# Sigtronics ICS Load Modification Instructions

Intercom Models: **Sport 200**  
**SPA-400**  
**SPA-600**

**SDB-800**  
**ST-400**  
**ST-600**

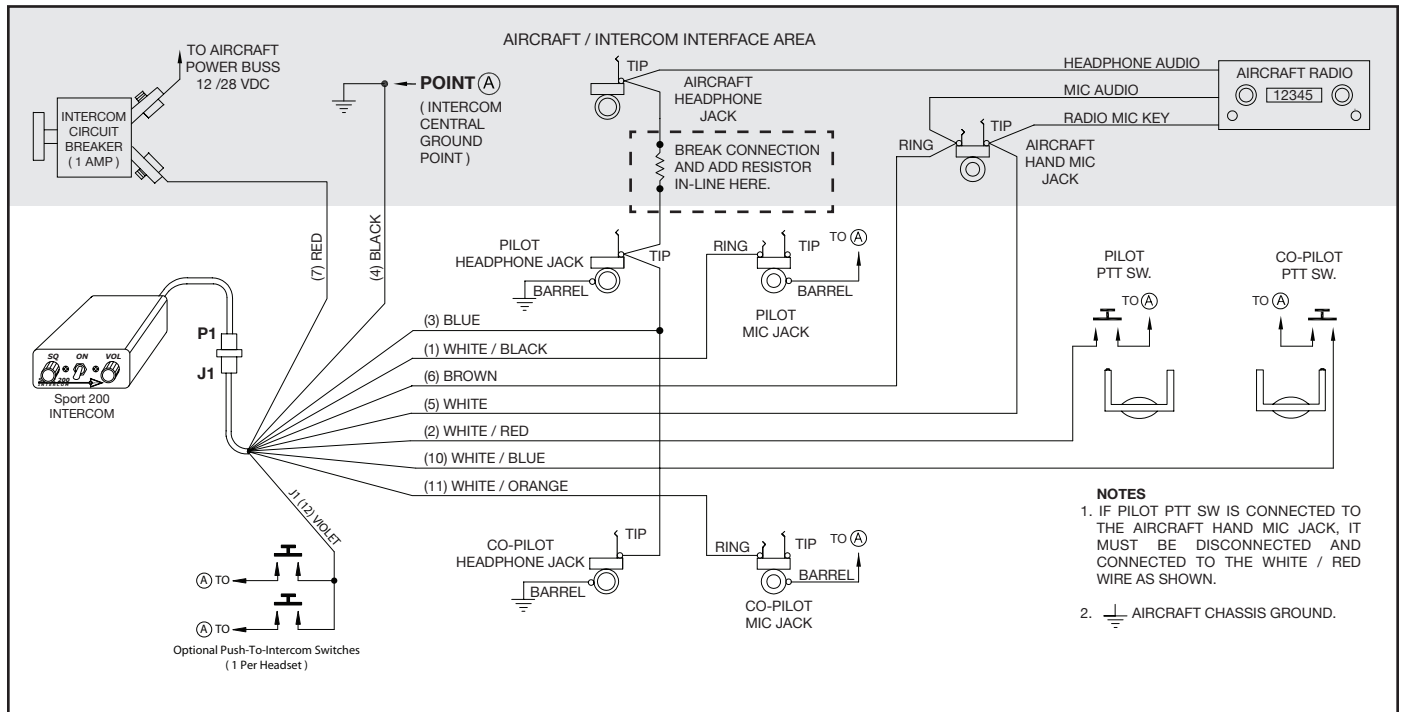
This modification is used when a Sigtronics Intercom is connected to a radio or audio panel which has a low impedance headphone output (less than 100 ohms). This is most common with some Narco equipment (CP-135, CP-136, and MARK 12D for example) and "home made" audio select panels.

**Symptoms Are:** Intercom audio volume is weak or non-existent.  
 Transmit function is normal on VHF radio.  
 Receive function is normal on VHF radio.

**Verification:** Disconnect the intercom headphone wire (blue) from the radio or audio panel. Make sure that the blue wire is still connected between the intercom and all intercom headphone jacks. If the maximum intercom volume level is now approximately 30% or more greater than when the blue wire was connected, then this modification will solve the problem.

**Solution:** Add a 1/4 or 1/2 watt resistor per the drawing below. The value of the resistor most commonly used is 220 ohms, however, optimum performance can be achieved by selecting the value right for your particular installation. The resistor can be any value between 100 and 330 ohms and is selected for the best balance between radio receive volume and intercom volume.

The example below is for a Sport 200 intercom. The resistor modification applies to all listed intercoms.
